**PLANNED UNIT DEVELOPMENT &
SUBDIVISION STAFF REPORT****Date: October 17, 2019**

<u>NAME</u>	Addison Woods Subdivision, Resubdivision of
<u>SUBDIVISION NAME</u>	Addison Woods Subdivision, Resubdivision of
<u>LOCATION</u>	3450 Girby Road (North side of Girby Road 160'± East of Hillcrest Road)
<u>CITY COUNCIL DISTRICT</u>	District 6
<u>AREA OF PROPERTY</u>	38 Lots / 16.3± Acres
<u>TIME SCHEDULE</u>	None provided

SITE PLAN

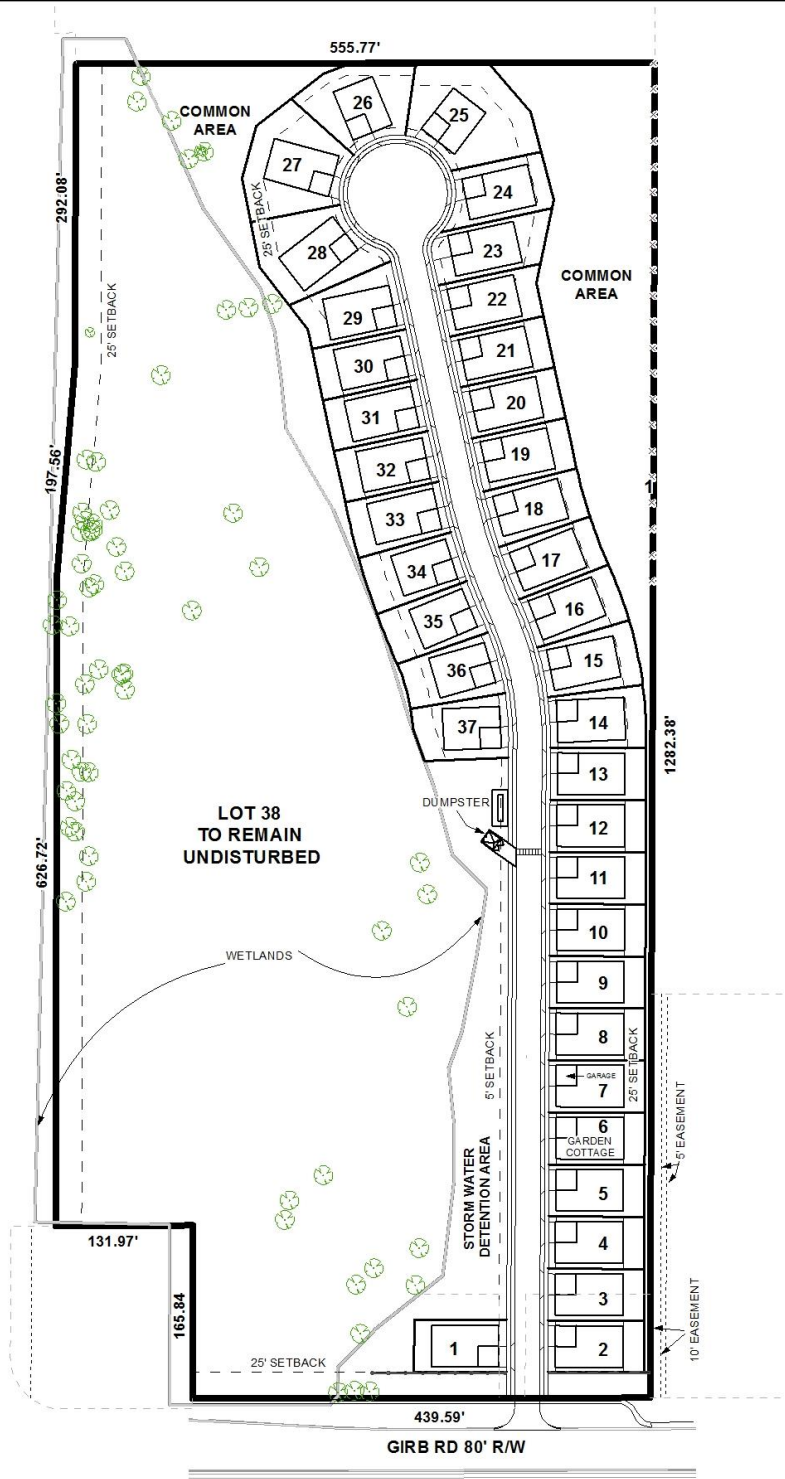
The previous PUD application proposed 29 garden homes with a clubhouse and associated parking for a community restricted to individuals 55 years and older. The current application proposes 37 garden homes, and does not mention age restrictions. The submitted site plan illustrates a dumpster and a mail kiosk to serve the development, rather than each dwelling having its own mail box and trash cans. The applicant also proposes either a six foot high masonry wall or privacy fence near the entrance to the development, setback 25± feet from Girby Road.

Also, the site plan indicates that a 6' tall privacy fence is required on the East property line where the site abuts B-2, Neighborhood Business District and R-3, Multi-Family Residential District; both of which are developed as apartment complexes. It should be noted that due to the proposed development consisting of single family dwellings, as opposed to the previous commercial development, the subject site is no longer required to provide a residential buffer for these properties. There is also a note stating that a privacy fence is not required due to dense vegetation along the North property line where the site abuts an R-3, Multi-Family Residential District that is developed with the Connie Hudson Senior Community Center. This note is also unnecessary, unless desired by the applicant.

The proposed private street appears to have a non-compliant right-of-way. Section VIII.E.2.c. of the Subdivision Regulations requires that private streets have a minimum right-of-way of 50 feet, and the plat depicts a 40 foot right-of-way. The right-of-way width should be revised to be the minimum required width. This may be achieved by shifting the lots on the West side of the street further to the West. This may result in the rear yards of some lots containing wetlands, but should not impact the buildable area.

Section VIII.E.2. has several other requirements that need to be addressed. First, the plat is required to have utility easements acceptable to the appropriate provider of utility services within the Subdivision, and there are none depicted. Second, the Final Plat should contain a note stating that the street is privately maintained and not dedicated to the public. Next, a note is required on the Final Plat stating that if the street is not constructed and maintained to City standards that 100% of the cost of the improvements will be assessed to the property owners (it should be noted that if the street is developed with a 40 foot right-of-way, it would not be eligible for City maintenance). Finally, a letter sealed by either a registered land surveyor or civil engineer must be submitted at the time the required seven copies of the Final Plat, stating that all of the requirements of Section VIII.E.2. of the Subdivision Regulations have been met.

- 1) Revision of the site coverage table to simplify the request;
- 2) Revision of the site plan to include the lot size table provided on the preliminary plat;

- 3) Revision of the plat to provide a minimum 50 foot wide right-of-way for the proposed private road;
- 4) Changing the proposed Lot 38 to either a Common Area or a Preservation Area;

- 5) Revision of the site plan to include utility easements acceptable to the appropriate provider of utility services within the Subdivision;
- 6) Placement of a note stating that if the street is not constructed and maintained to City standards that 100% of the cost of the improvements will be assessed to the property owners, if dedicated to the City;

- 7) Revision to accommodate any other requirements of Section VIII.E.2. of the Subdivision Regulations;
- 8) Revision of the site plan to reflect the previous dedication made along Girby Road; and

- 9) Address if the development will remain age restricted.
